HISTORIC AND DESIGN REVIEW COMMISSION

January 18, 2017 Agenda Item No: 04

HDRC CASE NO: ADDRESS:	2017-017 601 E CARSON
LEGAL DESCRIPTION:	NCB 993 BLK 3 LOT E 14 OF S 150 OF 4 ARB 8B,W 76.1 OF S 150 ARB 9B & PT OF 10B
ZONING:	R-6,H,HL
CITY COUNCIL DIST.:	2
DISTRICT:	Government Hill Historic District
LANDMARK:	House
APPLICANT:	Loyd Hawkins
OWNER:	Marlene Hawkins
TYPE OF WORK:	Install porch railing

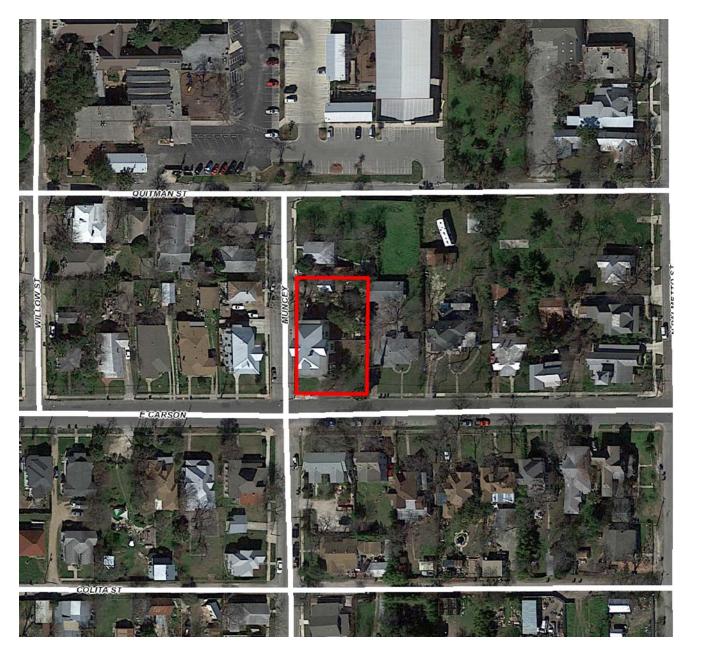
- a. The main structure is a two-story classical revival style home with a first story porch, a second story balcony, and a third floor dormer. It is located in the Government Hill Historic District, and was designated in 2002.

- b. The second floor balcony has a railing with square balusters. The proposed new railing matches the existing on the 2nd floor and wraps around the entirety of the front porch, with an opening for the existing front steps. According to the Guidelines for Exterior Maintenance and Alterations7.B.iv., added elements should be simple and not distract from the historic character. Staff finds that though there is no photographic evidence of a first floor balustrade. Staff also finds that that there are examples of classical revival homes with railings on the first floor porch. Staff finds the proposal appropriate and consistent with the Guidelines, as they are consistent with the character of the historic structure.

Staff recommends approval based on findings a and b as submitted. If the applicant is considering the rehabilitation of the primary historic structure, staff recommends the applicant apply for Historic Tax Certification.
